**Your reference: MCU25/0075**

**RESPONSE TO INFORMATION REQUEST  
DEVELOPMENT APPLICATION FOR MATERIAL CHANGE OF USE  
FOR MULTIPLE DWELLING (81 x DWELLING UNITS)  
344-346 ROSS RIVER ROAD, CRANBROOK**

## ROSS RIVER ROAD RESIDENTIAL

## **344-350 ROSS RIVER ROAD INFORMATION REQUESTS – RESPONSE TO TRANSPORT AND ACCESS ITEMS**

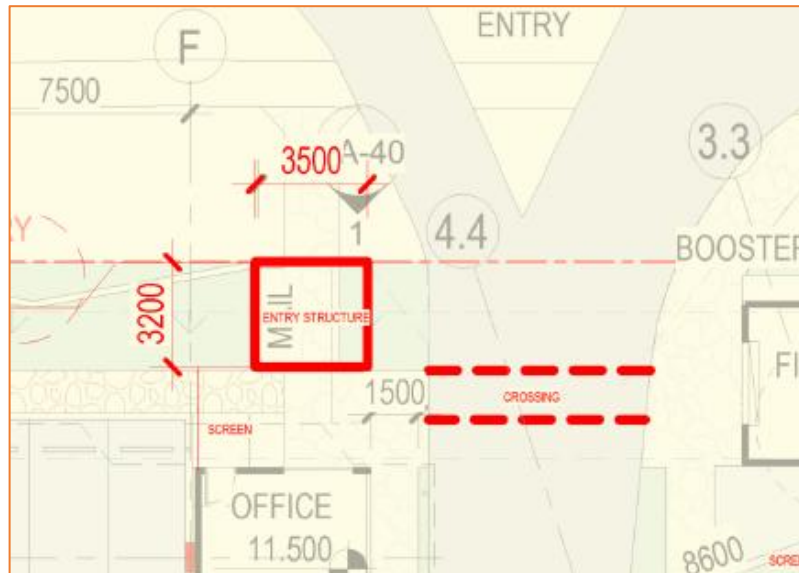
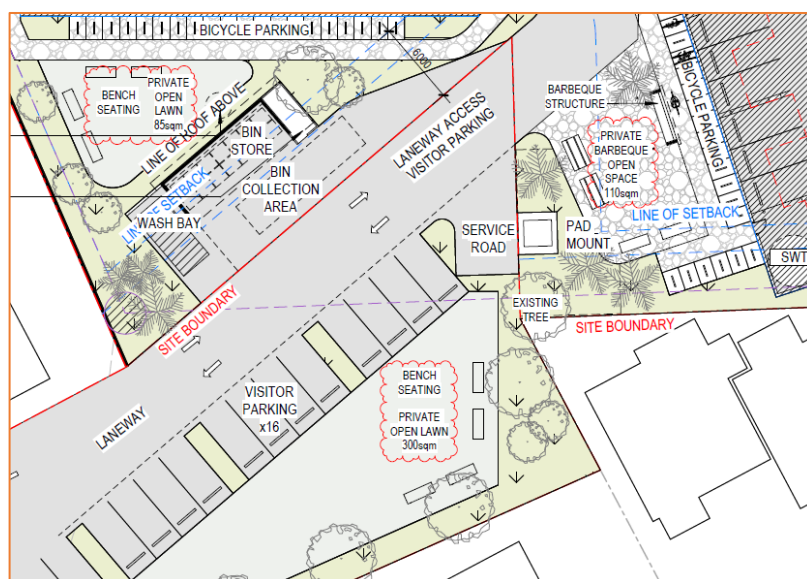
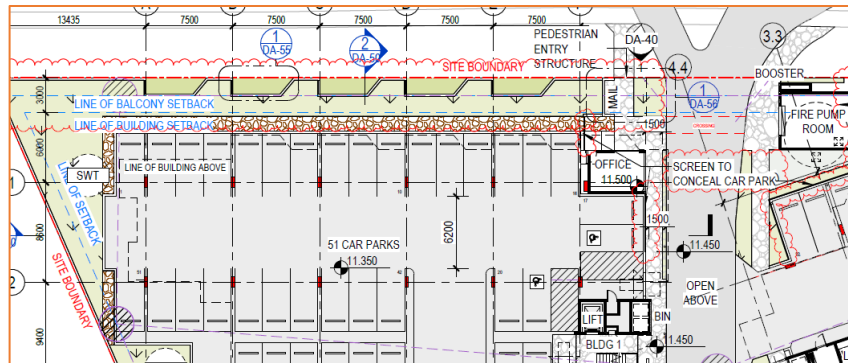
*The applicant is requested to provide amended plans incorporating the following design changes to improve the interface and engagement with the Ross River Road frontage:*

- *Clear pedestrian pathway access including a structure or gateway from Ross River Road that is separate from the driveway, and connects to an internal pedestrian pathway and communal space;*
- *Consideration of size of the private open space areas and demonstrate that each unit is provided with sufficient area to meet the resident's needs; and*
- *Redesign the ground floor elevation to provide built form elements to activate the street frontage and conceal the car parking on ground level from public view.*

- A clear entry structure is proposed, along with a pedestrian crossing – refer diagram below and **Appendix A**.

- The three areas to the rear of the site are to be designated open space areas. It is proposed that these areas will be embellished with trees and benches and a barbeque with associated structures (e.g. bench seating). Refer to diagram below and **Appendix A**. It is the applicants preferred option to provide barbeque and associated structures as opposed to loud activities such as basketball courts, skateboarding, etc. as mentioned in request item 2.

- It is proposed to activate the street frontage through the form of boundary fence line articulation and materiality. Further, screening to the car park through the vehicle entry is proposed to further conceal it from the street. Refer to below and **Appendix A**.

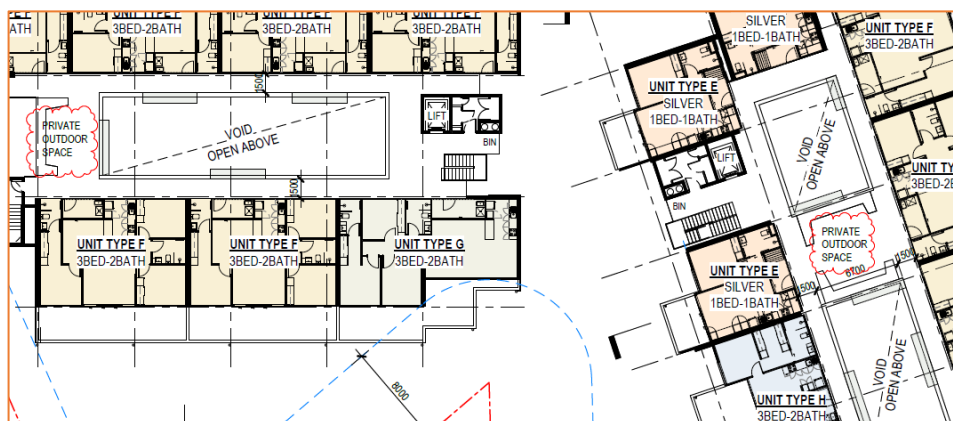
The applicant is requested to provide amended plans demonstrating provision of communal open space to service the proposed development, inclusive of appropriate facilities/embellishments to create flexible, usable spaces for residents.

Introduction of communal spaces on ground level has been demonstrated as a response to request item 1. Further, it is proposed that seating/gathering spaces next to the void for every 2nd level are provided. Refer to **Appendix A**.

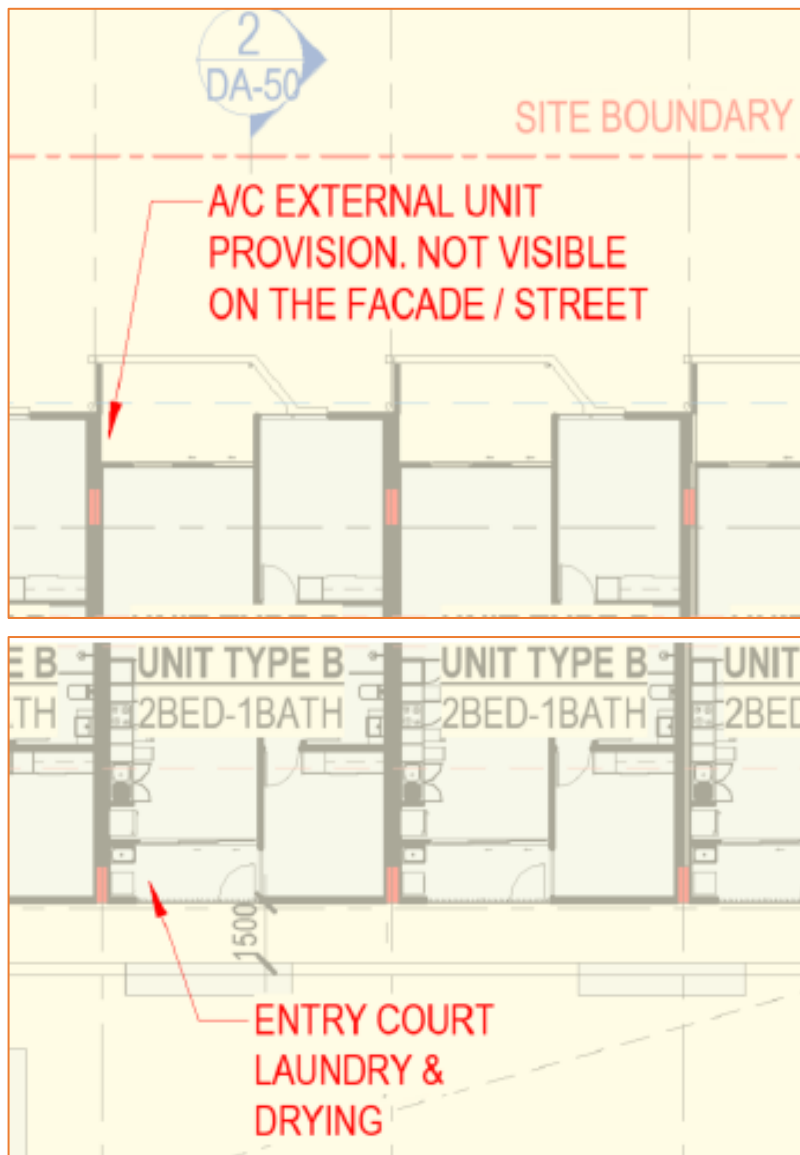
The applicant is requested to demonstrate the location of any utilities such as gas, water tanks or air-conditioning units for each dwelling unit, ensuring these are located outside of proposed private open space. The applicant is further requested to confirm if external clothes drying facilities are proposed and, if so, similarly demonstrate their location.

Air-conditioning units are to be located on the balcony, not visible from the street. Further, clothes drying facilities are located on the unit entry court not visible from public viewpoints. See diagrams below and **Appendix A**.

**DRAWING**  
ROSS RIVER ROAD  
PROPOSED ACCESS

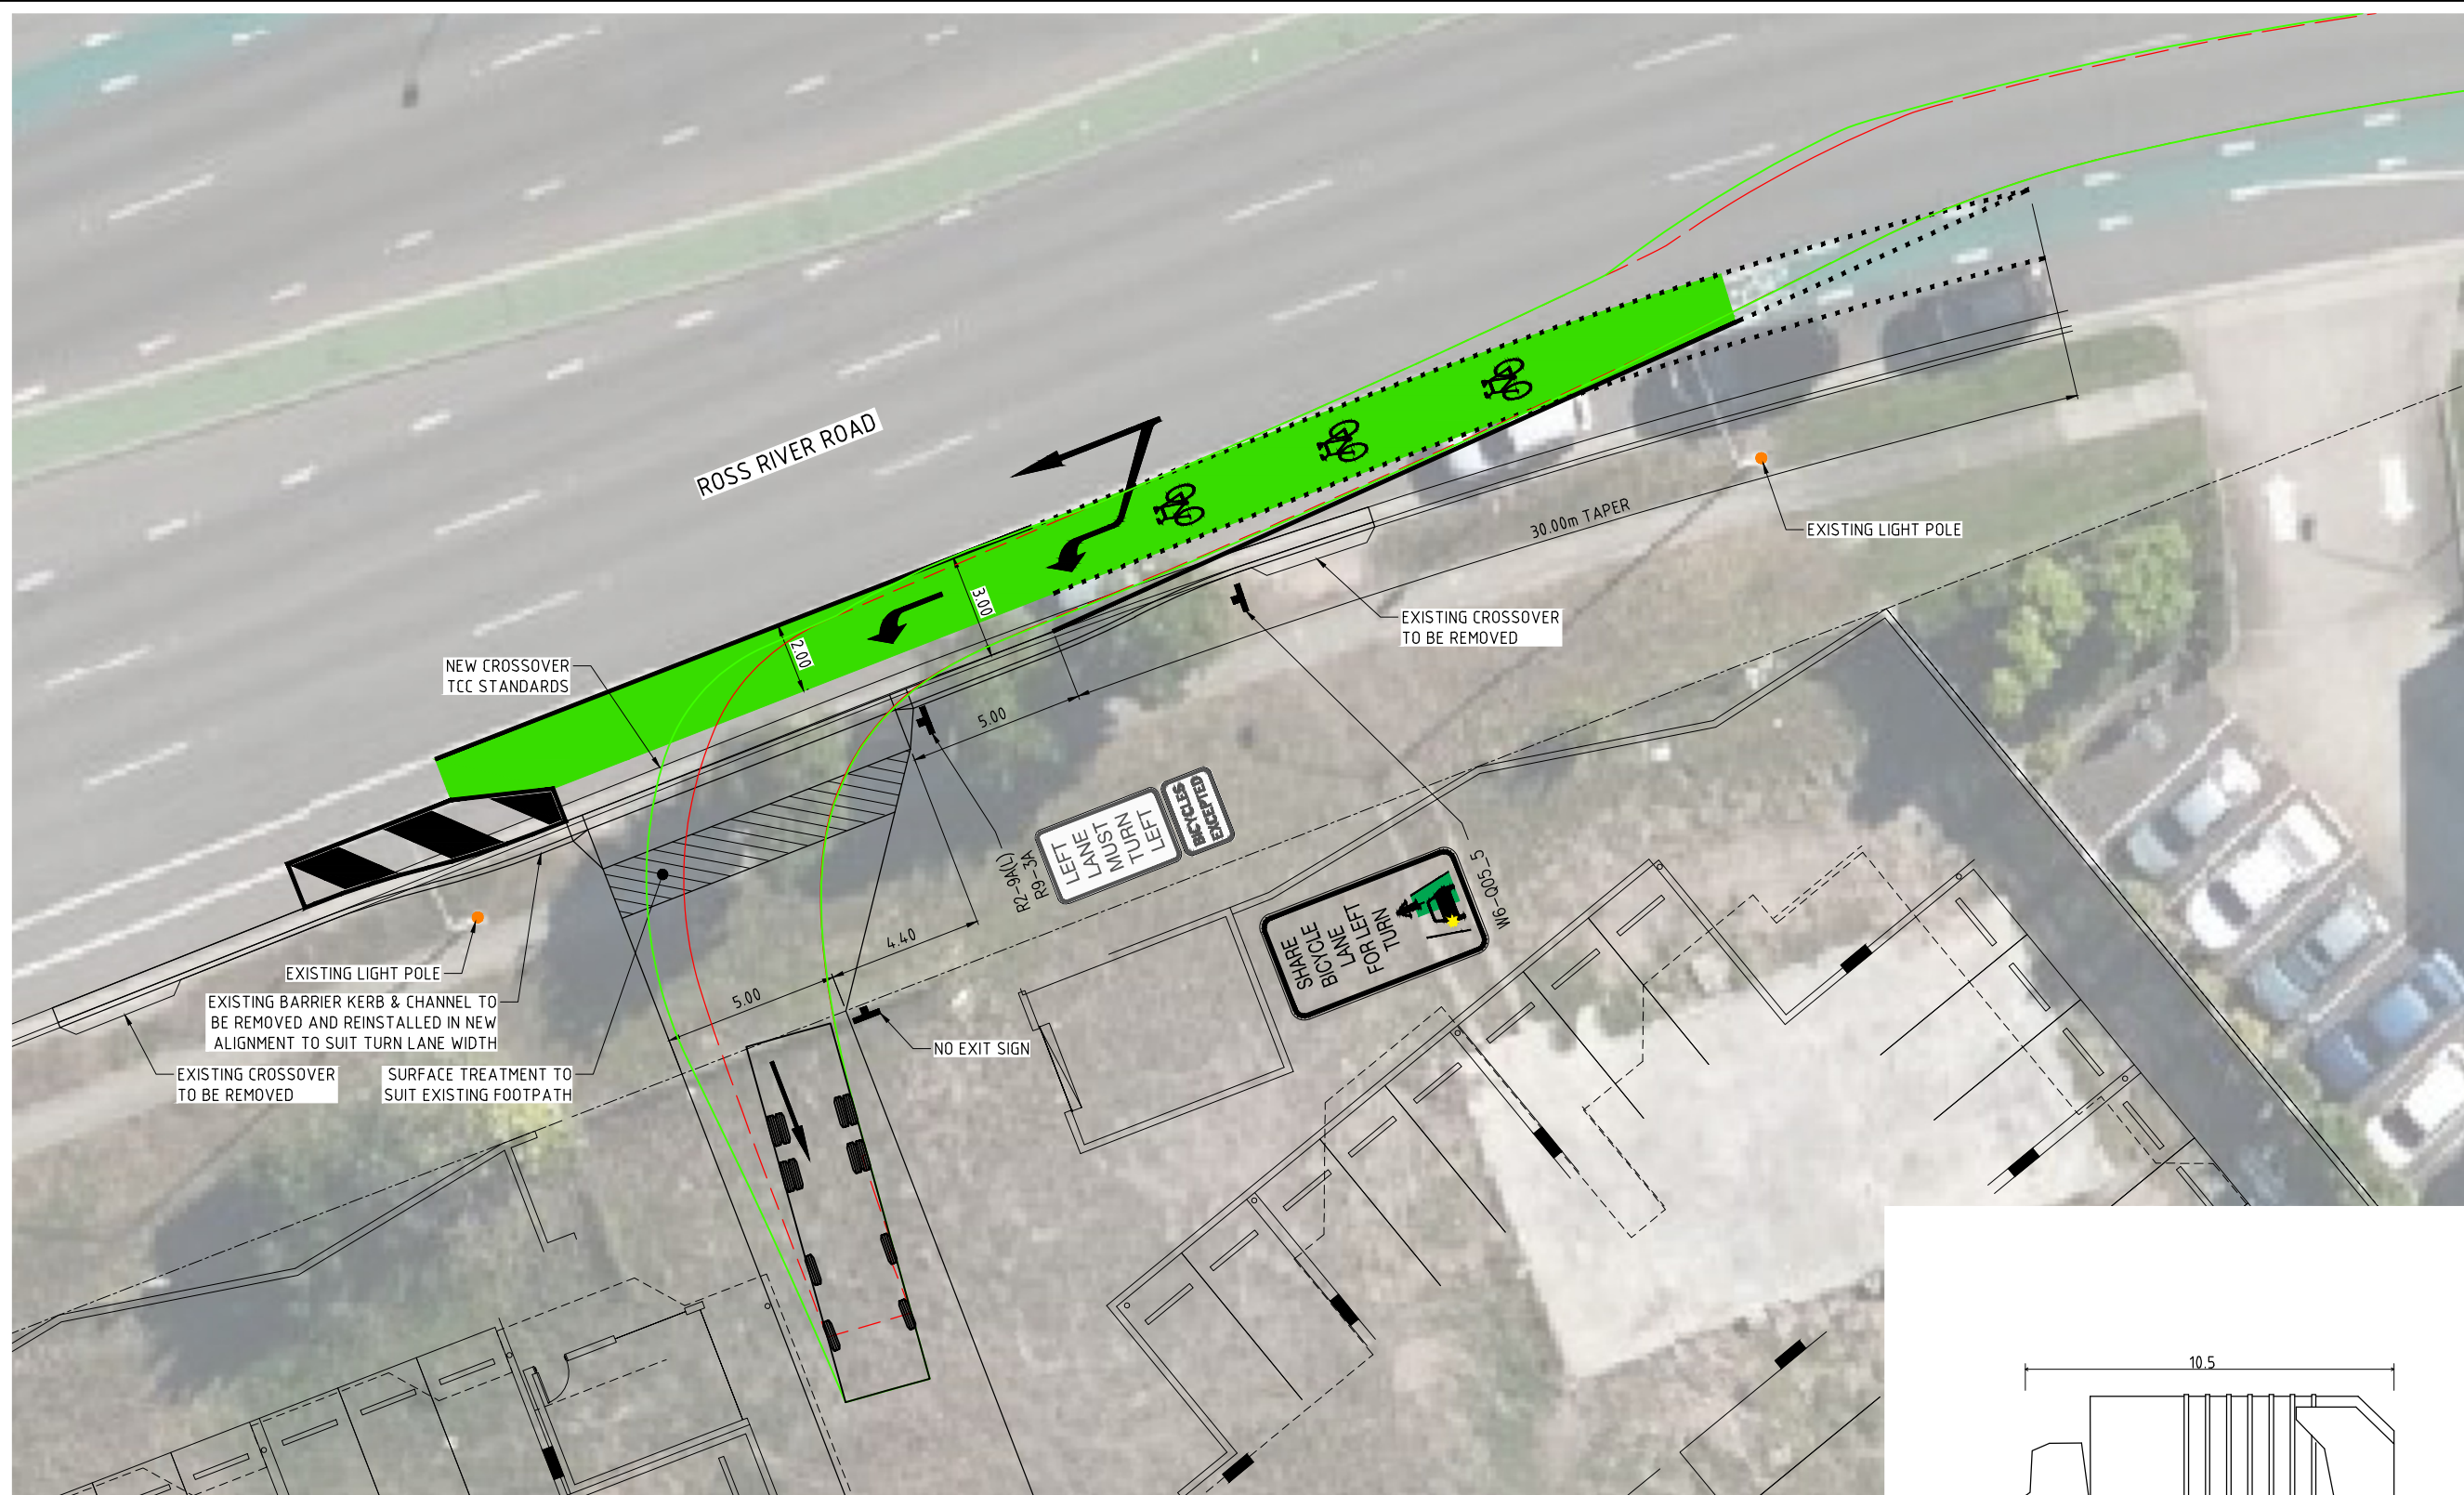
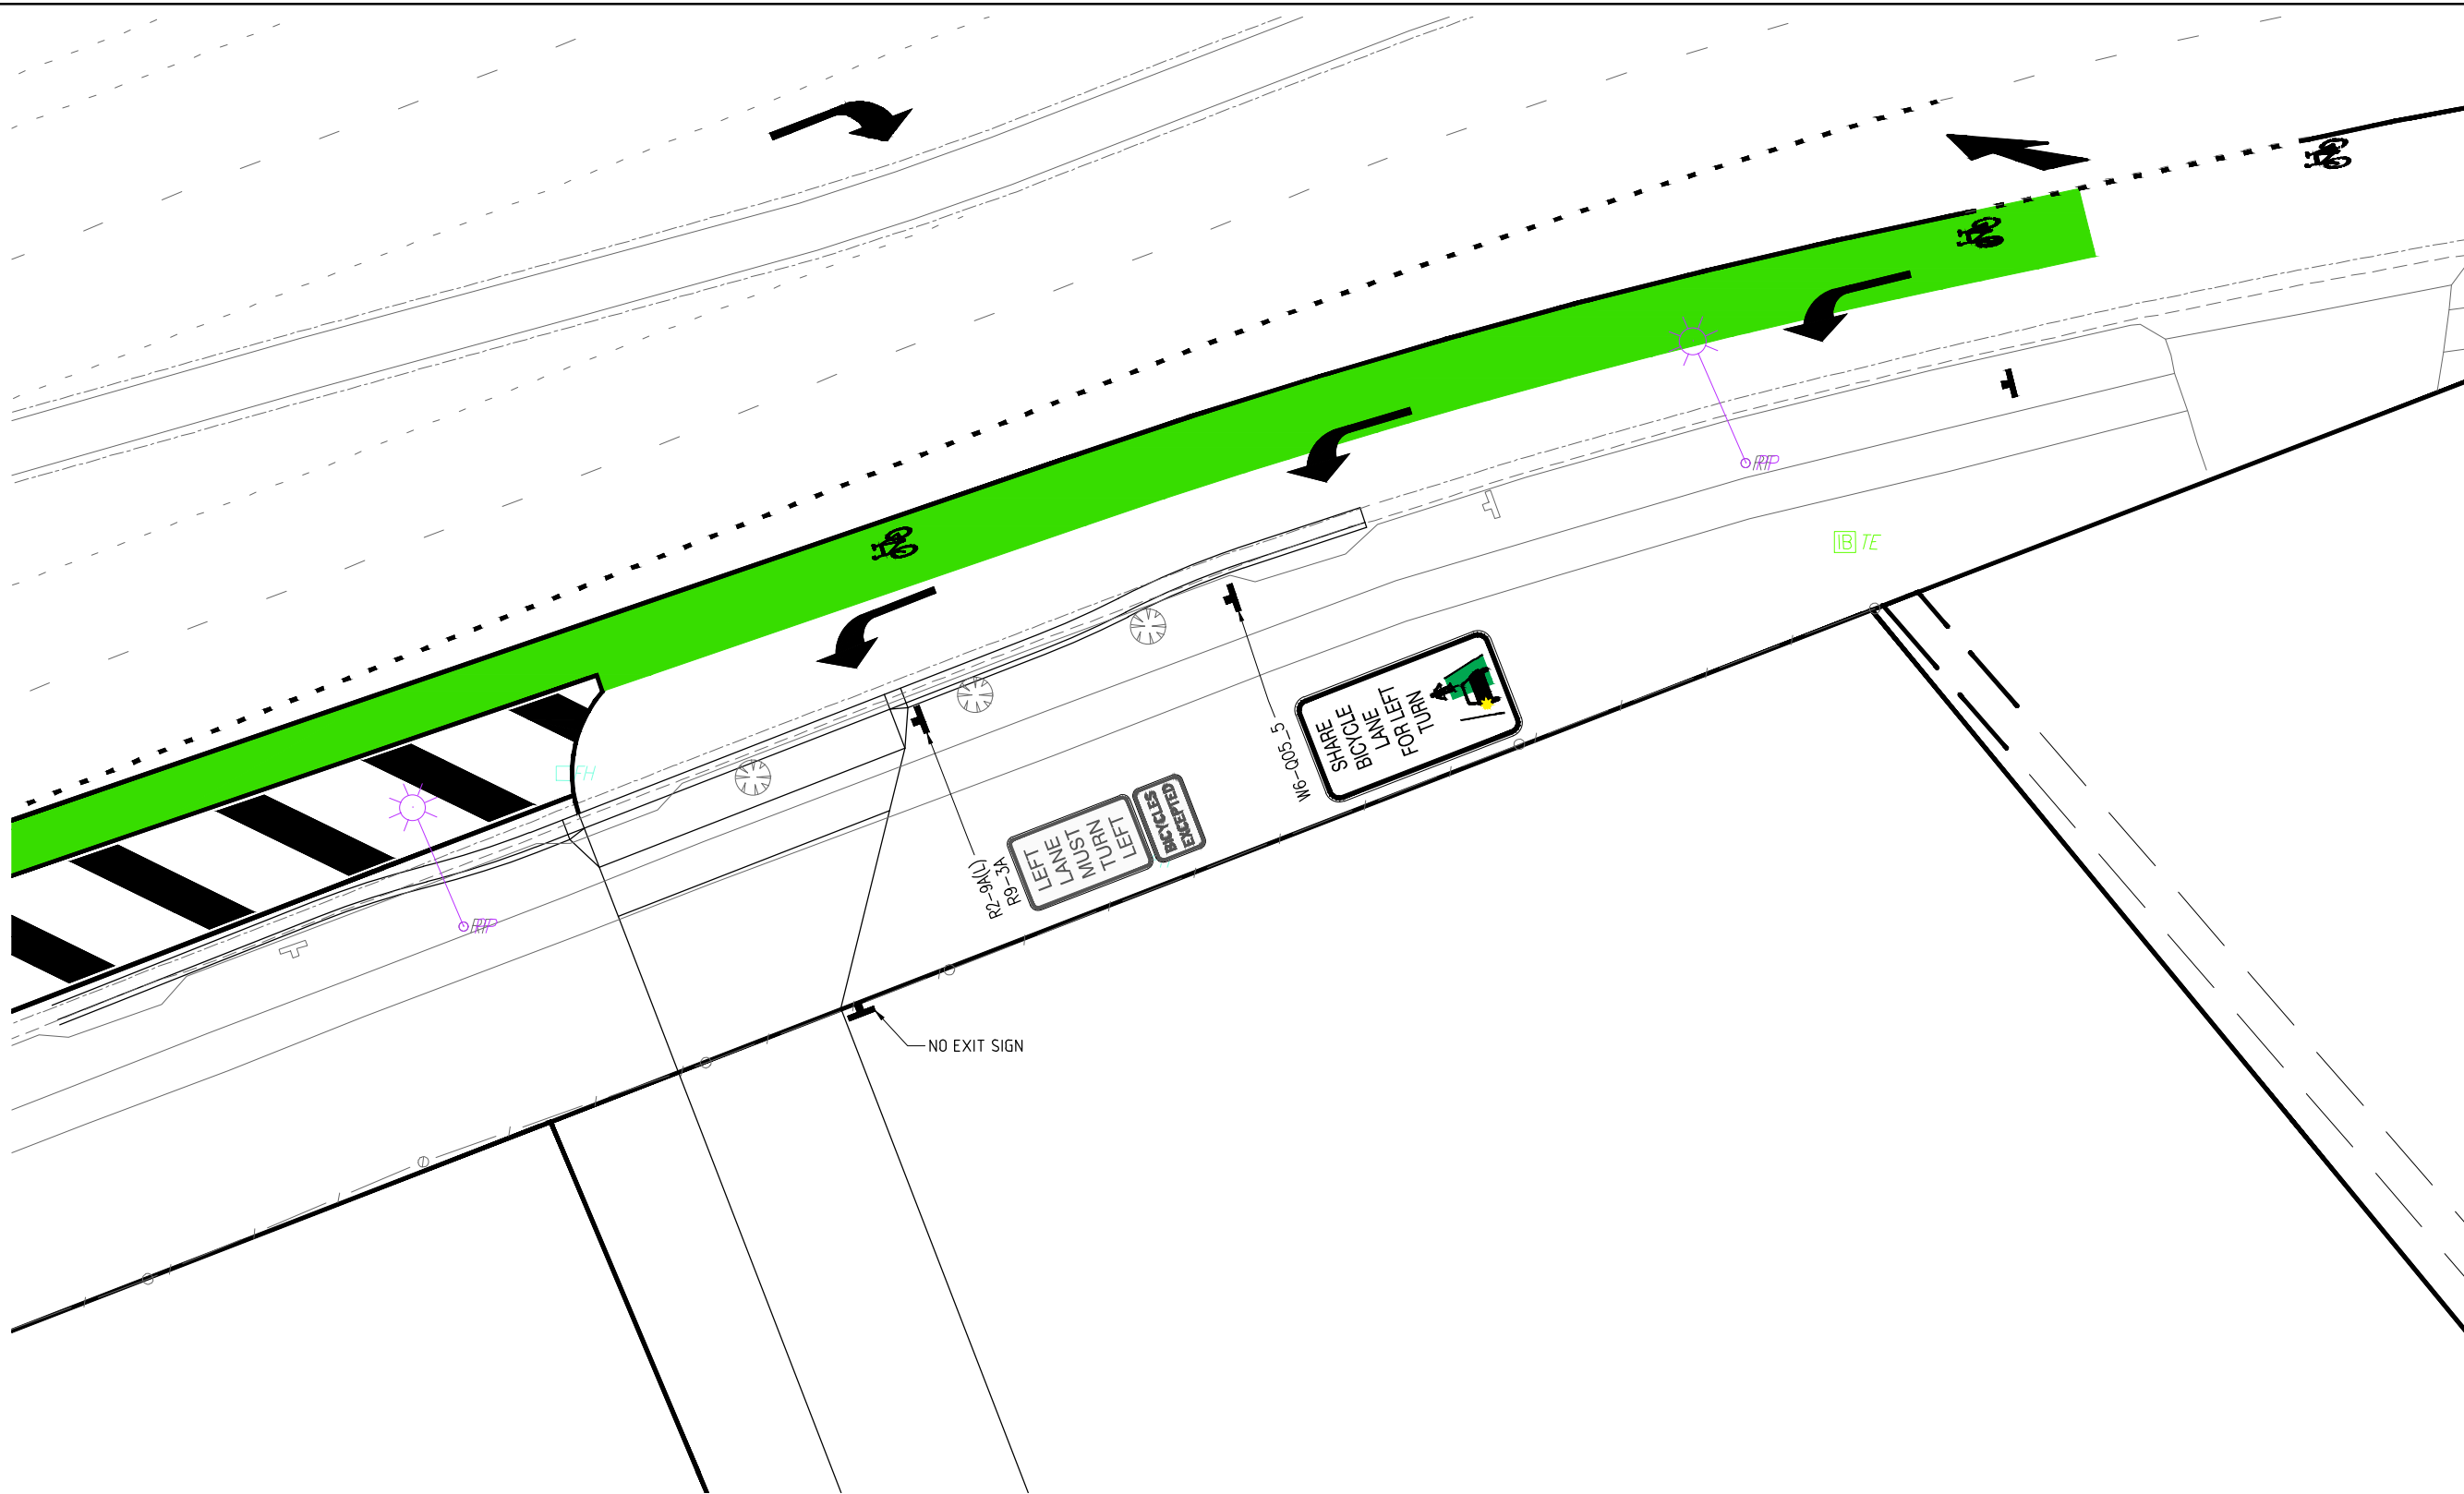
*The proposed exit-only onto Albert Street is considered to pose safety risks to pedestrians given the highly constrained sight lines caused by the existing block wall along the eastern access of the boundary, even with mitigation measures in place such as speed humps, convex mirrors or signage. The applicant is requested to consider alternative measures to improve safety at this location, such as converting the access to entry-only.*

- > The previously proposed exit to Ross River Road has been removed from the proposed Ross River Road access arrangement.
- > Entry from Ross River Road provides an auxiliary left turn treatment with a short turn slot (AUL(s) in accordance with the turn warrant assessment documented in Section 5.3.1 of P003620-R01revA.
- > The on-road bicycle lane is designed in accordance with TMR's approved as official traffic sign W6-Q05\_2 Retrofit Bicycle Lane in a Left Turn Lane "Unsignalised Intersection". This is the same treatment as proposed by TMR in future road network planning for entry to 340 Ross River Road.
- > The entry driveway will be constructed with vertical deflection that slows approaching drivers in accordance with Section 6.14 of TMR's 2021 guideline.

HURA018-SK8-A shows the proposed Ross River Road access in the context of TMR planning for a westbound merge point (from three into two lanes) at the site's frontage. The planned merge increases the shoulder width available for the on-road bicycle lane and AUL(s) which may allow the W6-Q05\_2 treatment to be removed.
